**NON CONSOLIDATED OICA COMMENTS ON EVSC #2
(DOCUMENT 05-38)**

Annexe 21

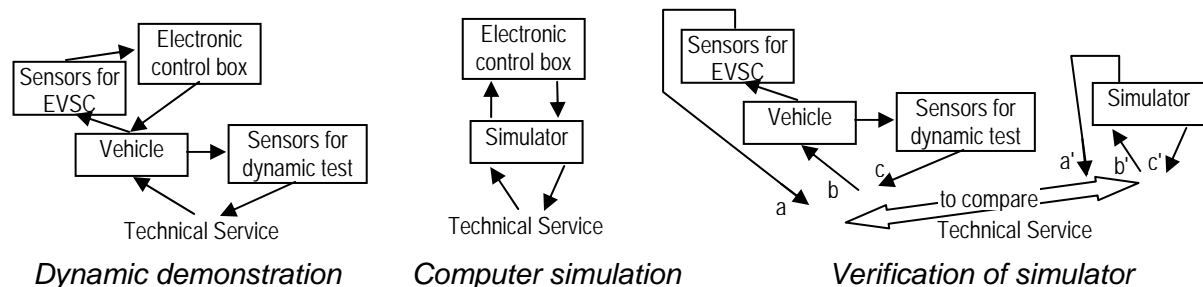
- Amend the paragraph which mentions the computer simulation, to read: "a computer simulation, together with data which verifies the simulation model against ~~a practical test~~ **the real vehicle behaviour and the real sensor characteristics.**"

Justification: In the case of a computer simulation, not only the electronic control box but also the performance of the sensors used by the stability system have to be considered.

Verification of simulator means that for a given input $b=b'$, the differences $\Delta a=a'-a$ and $\Delta c=c'-c$ are below a given threshold (see §4.2 of Appendix 1).
